BUILDING PERMIT

Job ID: 2011-04-809-ALTCOMM

has permission to Reconfigure the location of the alignment bay/sales area and add mezzanine above the sales /waiting room provided that the person or persons, firm or corporation accepting this permit shall comply with all of the provisions of the Statues of Maine and of the Ordinances of the City of Portland regulating the construction, maintenance and use of the buildings and structures, and of the application on file in the department.

Proposed Project Description: 195 Riverside Street : Interior alterations to add a mezzanine		Pedestrian Activities District (P.A.D.) <i>5/16/11</i>	
Permit Taken By: Lannie		Zoning Approval

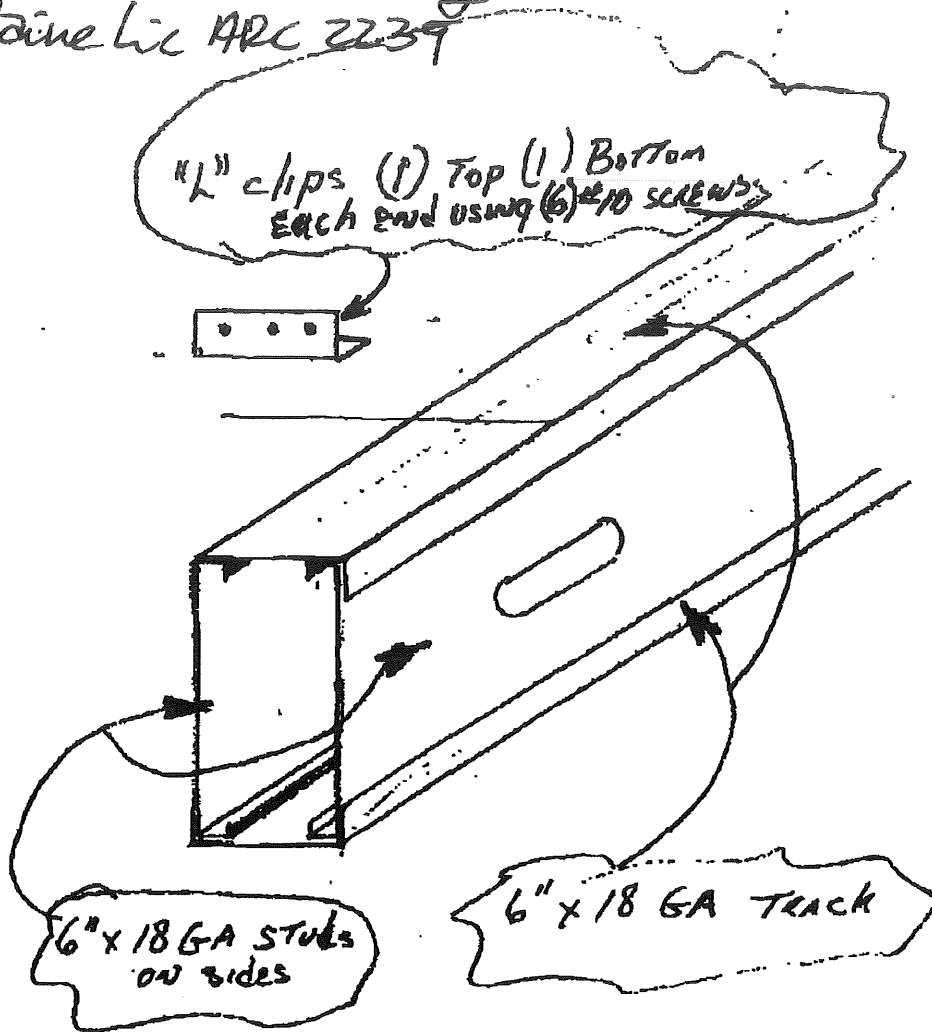
Also, as I discussed with you he has used steel studs for the wall framing in place of the 2 X 6 wood you have on the plans. On the customer service walls he used 18 g metal studs 12" OC to hold the second floor decking.

The above is acceptable. Attachment of alignment bay studs at the ceiling must be to solid rafters or solid blocking.

DOTEN'S CONSTRUCTION

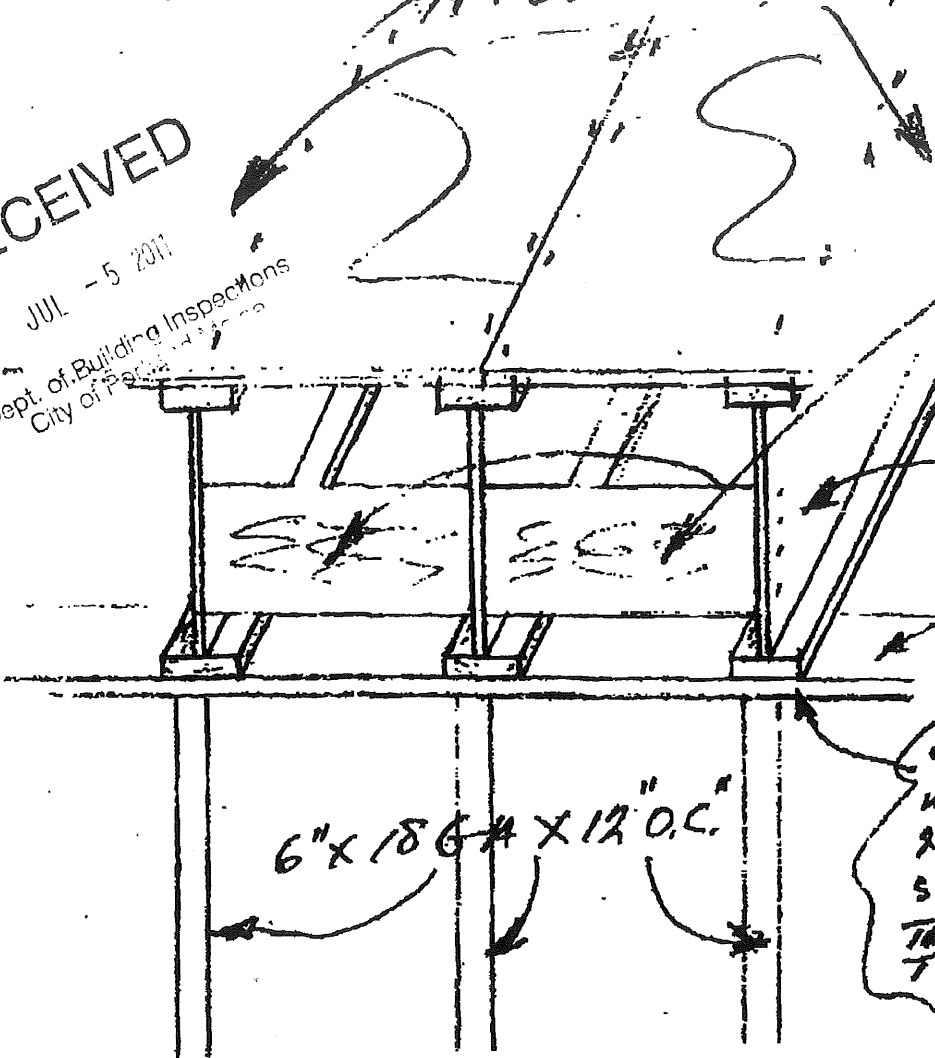
NOTE: There are
Four rows of 2x8 KD
Blocking applied, a row
at each end + 2 row
equally space in open
span

Acceptable
Robert Mocarisky
Maine Lic #ARC 2239 3/4 ADVANTEX decking
